ASSESSMENT REPORT

MIXED USE DEVELOPMENT, EASTLAKES SHOPPING CENTRE MP 09_0146 MOD 1

Figure 13: Approved Section at Gardeners Road (source: approved plans)

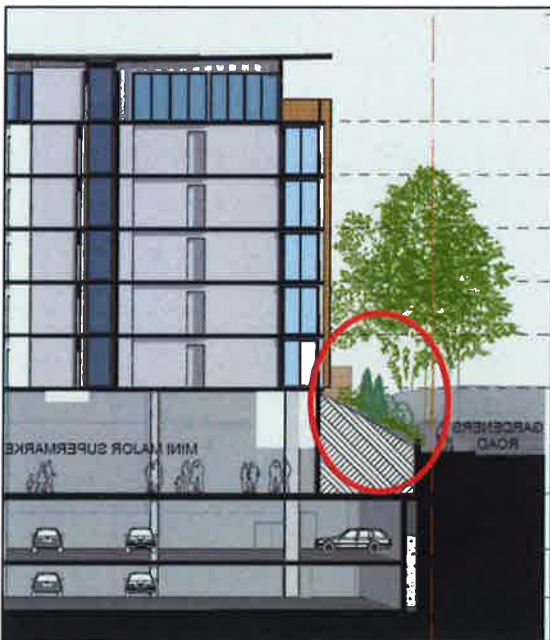
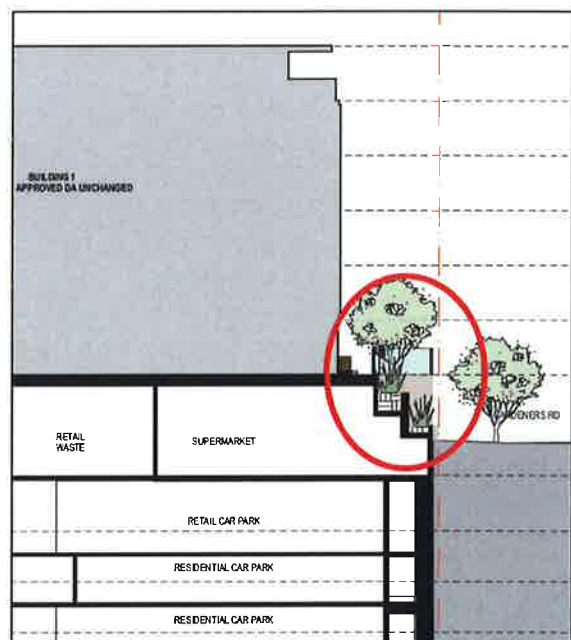
The modification seeks to extend the footprint of the podium towards the Gardeners Road boundary to provide additional retail floorspace. The Department initially raised concerns with this aspect of the modification, as it would result in a tall unbroken wall, up to six metres in height facing Gardeners Road (see **Figure 11**). Further, the revised design could not accommodate landscaping or trees within the front setback.

- the lower planter on the western side of the podium has a soil depth of only 400mm which can only support small ground covers. The Department considers the appearance of the podium could be significantly improved by lowering the base of the planter so it can support additional landscaping. A condition has therefore been recommended to this effect.
- at the western end of the podium, facing Gardeners Road, the podium wall extends above the emergency exit and service doors, resulting in a 5-metre-high structure at the edge of the footpath (see **Figure 15**). To reduce the visual impacts of the podium at this part of the site, the Department recommends the height be reduced to no greater than 3 m above the footpath and it be setback consistent with the remainder of the podium.

To address these concerns, the Proponent amended the design and incorporated a stepped podium along the Gardeners Road frontage. This has reduced the height of the podium wall at the footpath to a maximum height of 1.8 metres and allowed significant tree and shrub planting within the setback. Images of the proposed and approved development are shown in **Figures 13 to 15**. The Department considers the overall appearance of the proposal would now be similar to the approved development, albeit in a stepped, rather than a sloped form.

With a reduction in the podium massing at the western end, the provision of replacement street trees as well as landscaping within the front setback, the Department considers the proposed modification would retain a similar appearance to Gardeners Road as the approved development.

Figure 16: Approved layout of southern site showing the area on Evans Avenue that will be additionally overshadowed by the proposed building and the area overlooking the park that will have good solar access in the afternoons. (Base image source: approved plans)

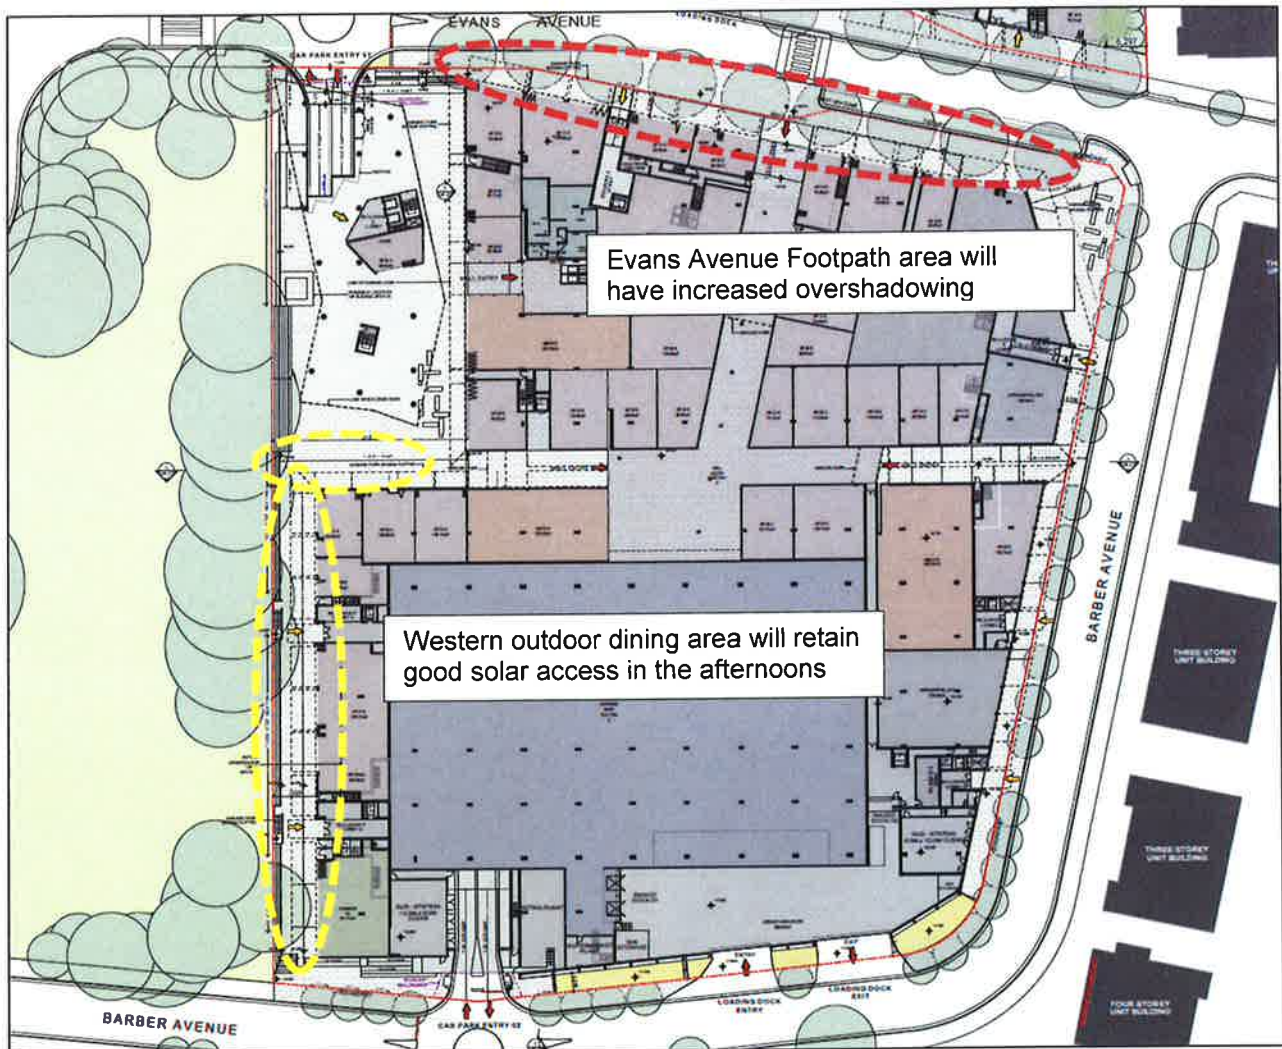
The increase in building height would result in additional overshadowing of the footpath throughout the day in mid-winter, although parts of the footpath would still receive sunlight at various times during the day.

In addition, the Department notes the footpath and any future outdoor dining areas would receive some access to sunlight at mid-winter and very good access to sunlight at other times of the year. Further, the approved development on the southern site incorporates retail units with the potential for outdoor dining overlooking the park to the west of the site, with excellent access to sunlight in the afternoon throughout the year (**Figure 16**).

Therefore, despite the additional overshadowing of Evans Avenue, the Department considers the modified development would still provide for active frontages along Evans Avenue with opportunities for outdoor dining.

Figure 17: Typical floor plan levels 2-6 showing setback control encroachment (base image source: Modification Request)

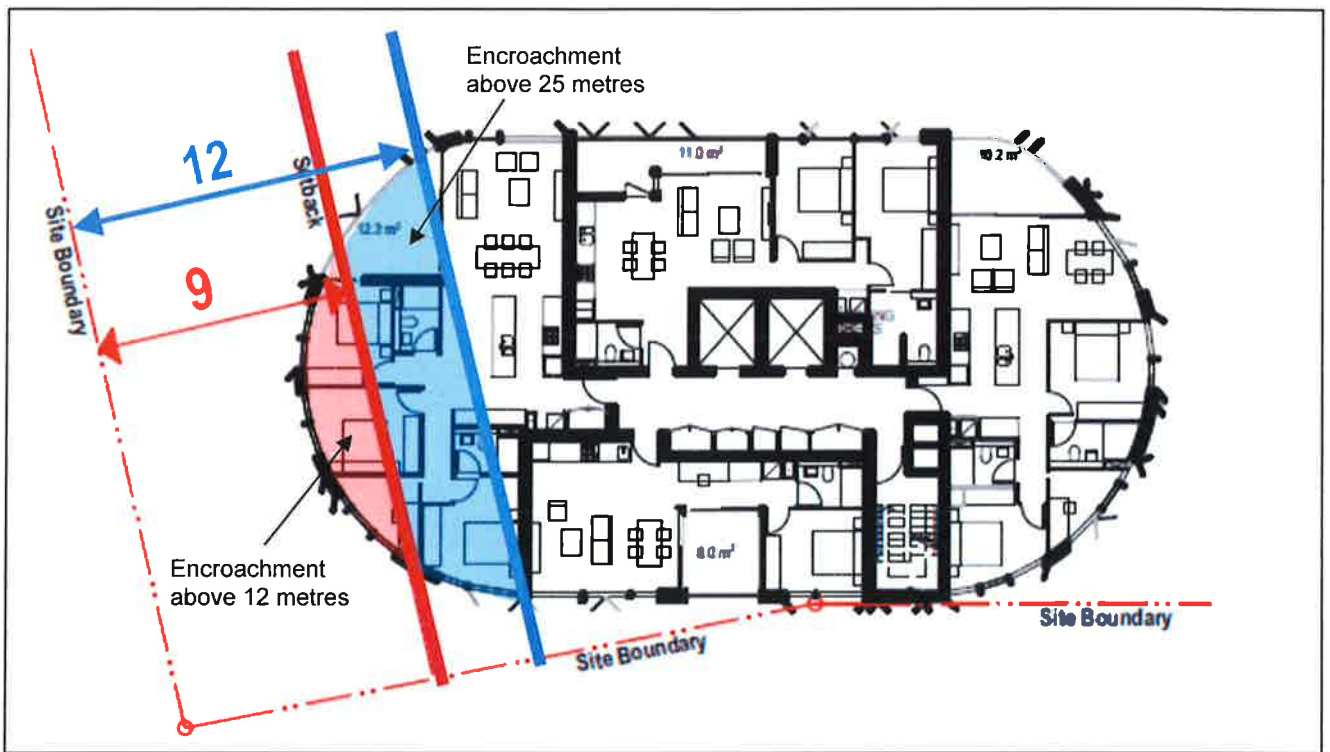
Building 1B would have a maximum height of 32 m to the top of the parapet and setback 6.47 m from the boundary with 16 Evans Avenue at its closest point. The proposal would therefore exceed the setback controls above 12 and 25 metres respectively. The extent of the non-compliance with the controls is shown in **Figures 17 to 19**.

The Department considers the proposed building separation is acceptable in this instance, given the proposed setback has been increased compared to the original approval (see **Figures 4 and 5**). Further, the Department considers the design of the building would minimise the potential visual impacts of the encroachment, as it would present as a slender curved shaped building, at the western boundary of the site.

To minimise potential privacy impacts on 16 Evans Avenue, the Department recommends additional privacy screening be provided to bedroom windows and balconies closest to the boundary and access to the edge of the roof terrace be restricted. The Department has recommended an amended condition requiring the above measures to be provided accordingly.

Figure 21: Proposed section through eastern boundary setback area (Source: Proponent's RTS)

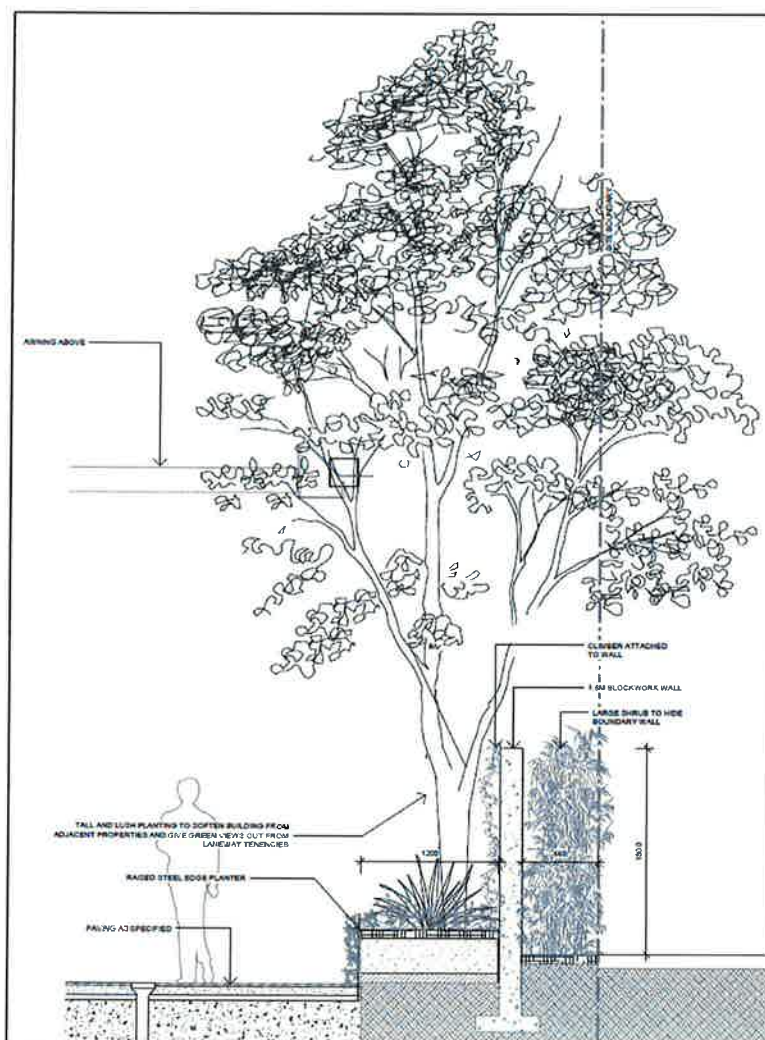
The Department considers the revised landscape treatment has the potential to provide a similar outcome to the approved development as it would appropriately screen the development. However, the proposal incorporates an awning above the setback area which may interfere with the proposed landscape planting. A condition is therefore recommended requiring the size of the awning to be reduced so that it does not extend into the tree canopy.

The Department also notes the Proponent's advice that the area will not be used for outdoor dining. To confirm this, the Department has recommended a condition specifying that no approval is granted for the use of this space for outdoor dining. The Department also notes existing conditions require the area to be lit at night and include CCTV to improve safety and reduce opportunities for concealment or entrapment.
